Service Bulletin

Maintenance of Way Equipment

RRP Service Bulletin No: RRP SB371

Title: Ignition Switch Heat Shrink Kit

Ignition Switch Without Heat Shrink.

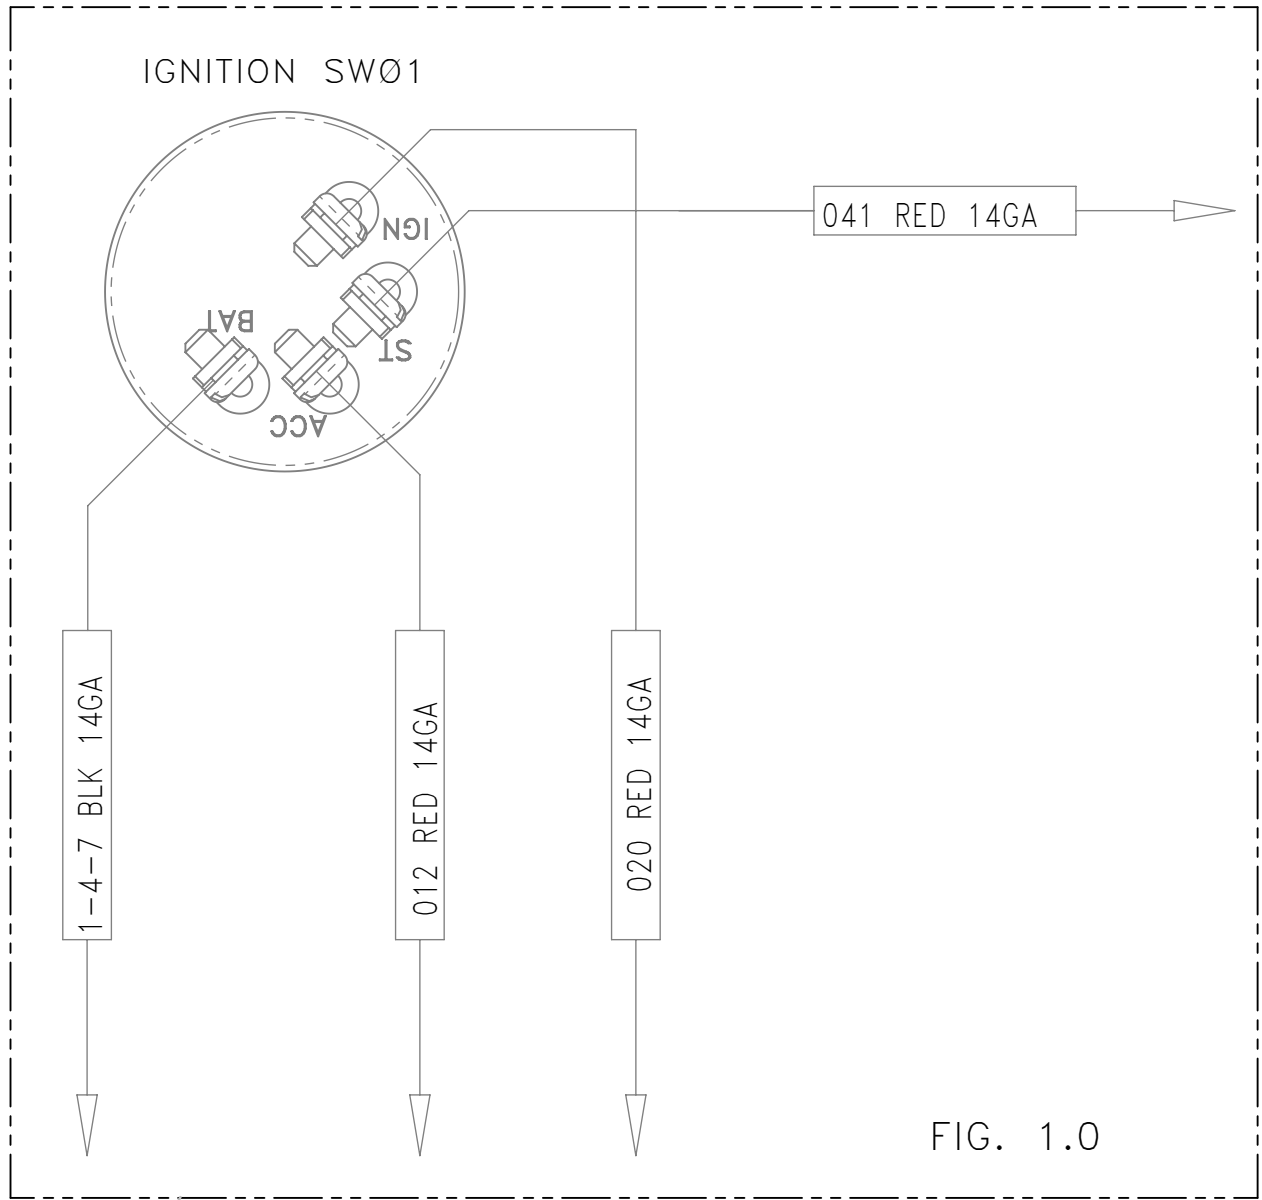
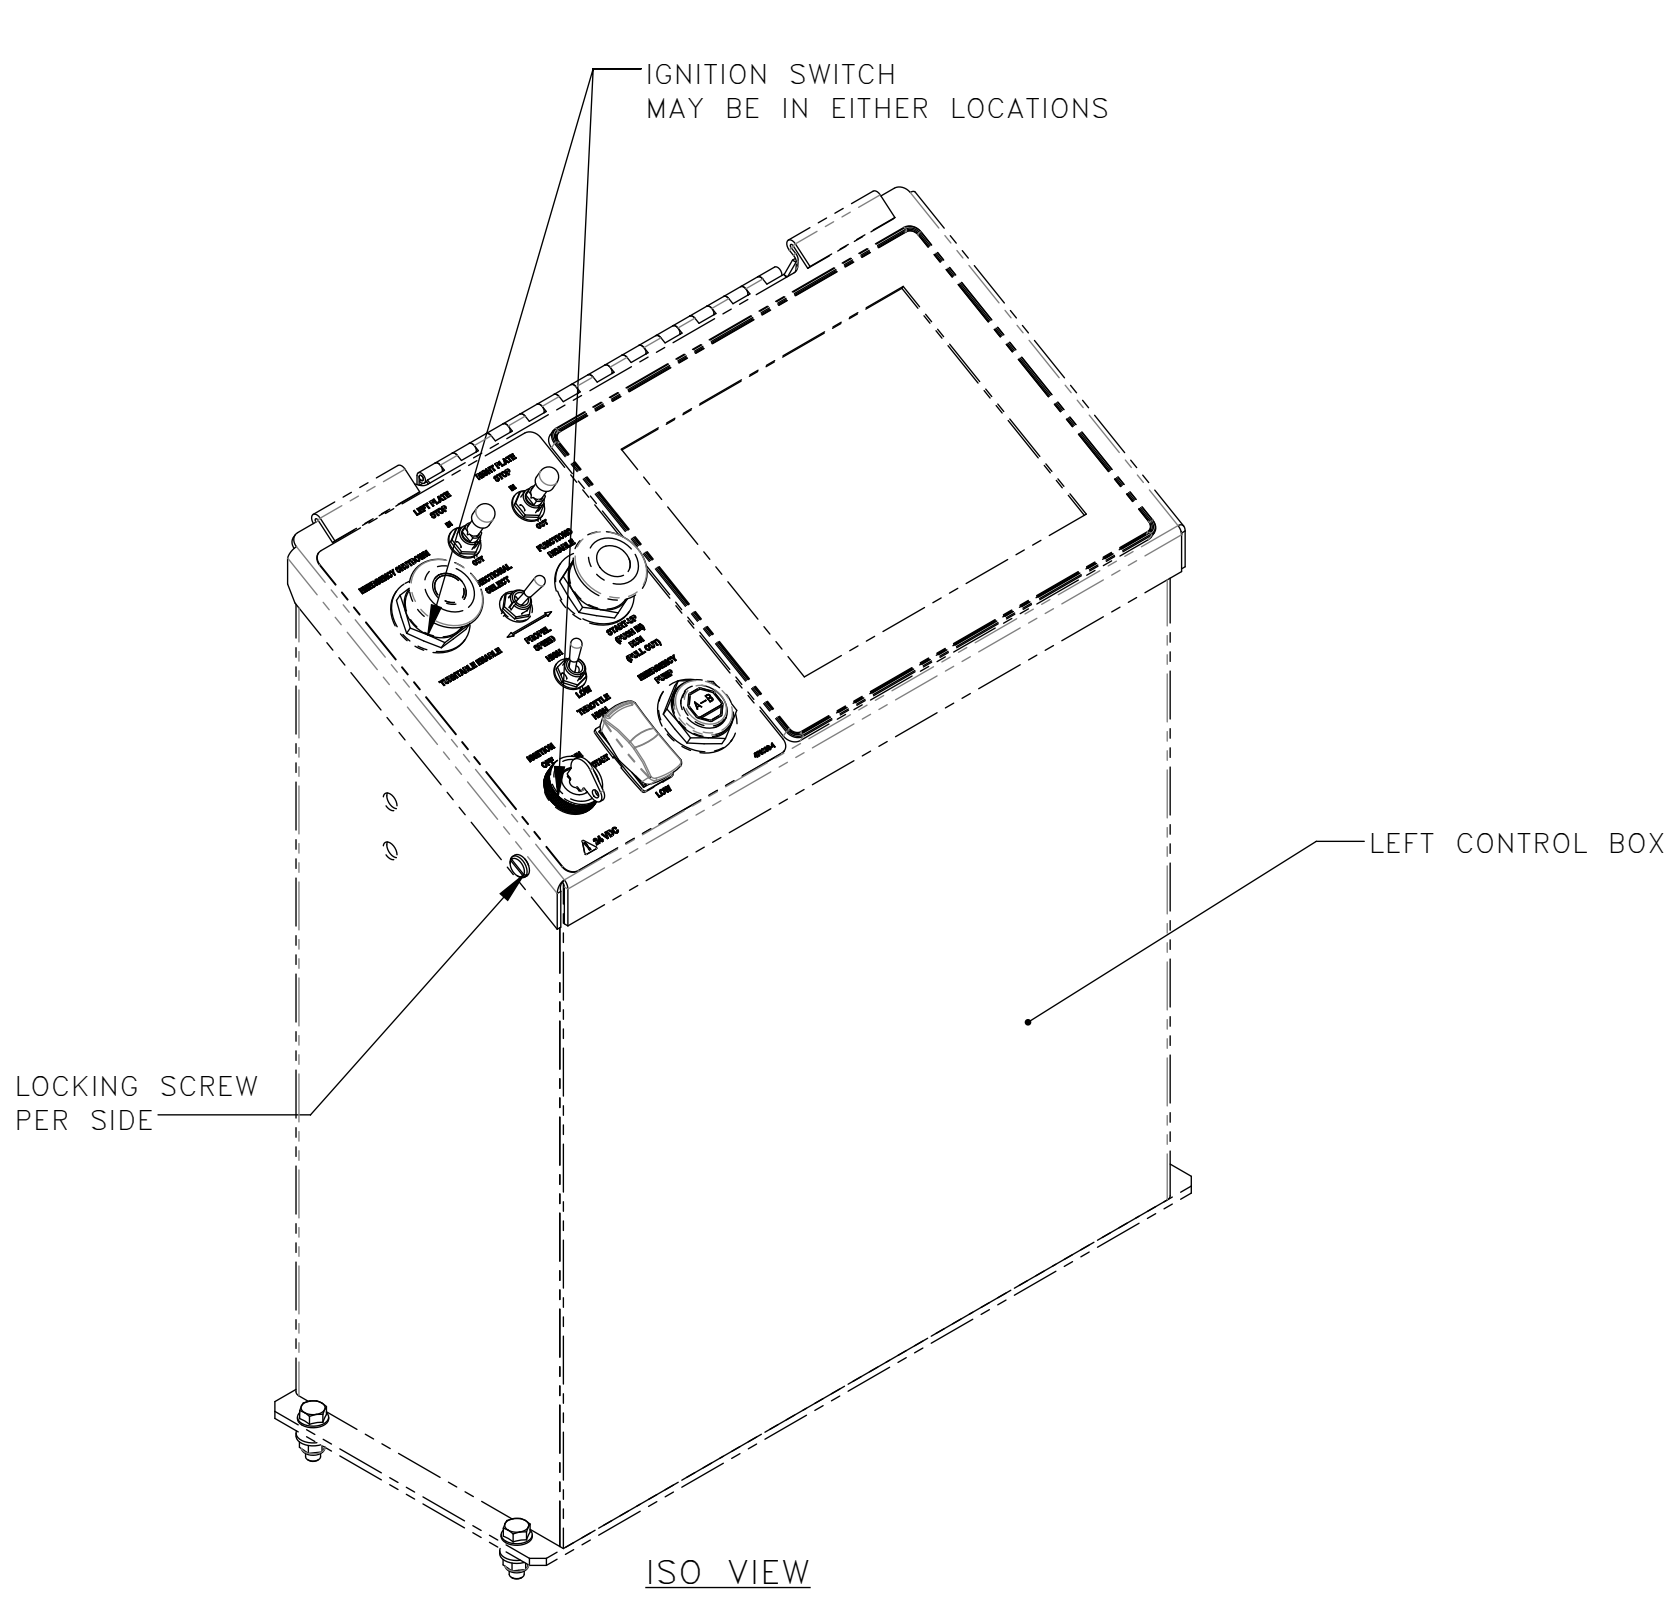
Summary: The ignition switch may short out due to the terminals being too close to the left control box housing. The switch may also loosen causing the terminals to rotate and contact the left control box housing, causing a short.

Action: Install heat shrink over the ignition switch to prevent the terminals from making contact with the left control box housing. Refer to the instructions on the following pages for details on installing the heat shrink.

Ignition Switch With Heat Shrink.
